April 2019
FL807A-E
NHTSA #19V-093
Transport Canada #2019-066
REVISED NOTICE

Subject: Hendrickson 5 Inch Drop Axle Tie Rods

Models Affected: Specific Freightliner Cascadia vehicles manufactured April 30, 2012, through May 26, 2015, equipped with Hendrickson 5 inch drop axle tie rods, brake linings, and stamped spiders.

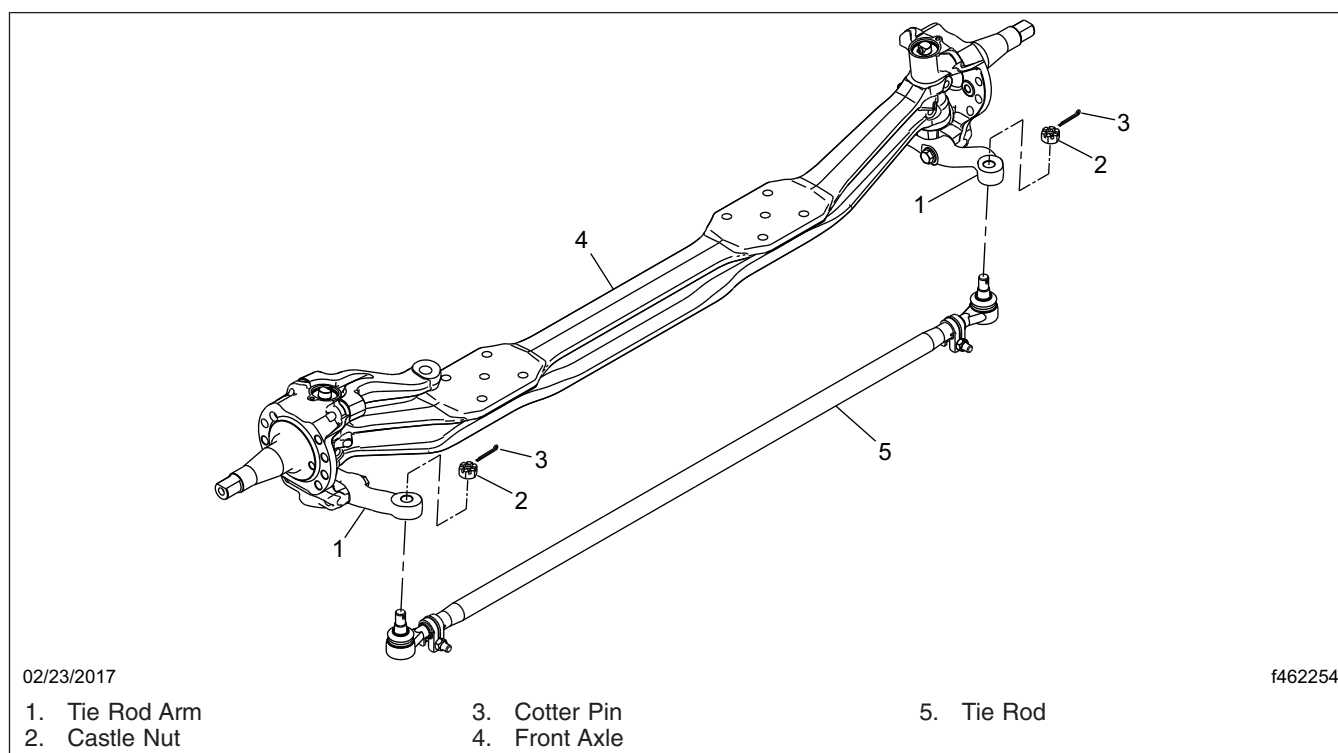
6. Remove the brake assembly. Refer to the applicable section in **Group 42** of the *Cascadia Workshop Manual*.
7. Disconnect the tie rod from the tie rod arms; see [Fig. 1](#). Remove the tie rod from the vehicle and discard it.

8. Attach a new tie rod to the tie rod arms. Tighten the castle nut 120 to 170 lbf-ft (163 to 230 N·m) plus a maximum of one-sixth of a turn to align a slot in the castle nut with the cotter pin hole in the tie rod stud. Insert the cotter pin and bend the tangs to secure it.
9. Clean and inspect all brake parts that will be reused. Refer to the applicable section in **Group 42** of the *Cascadia Workshop Manual*.
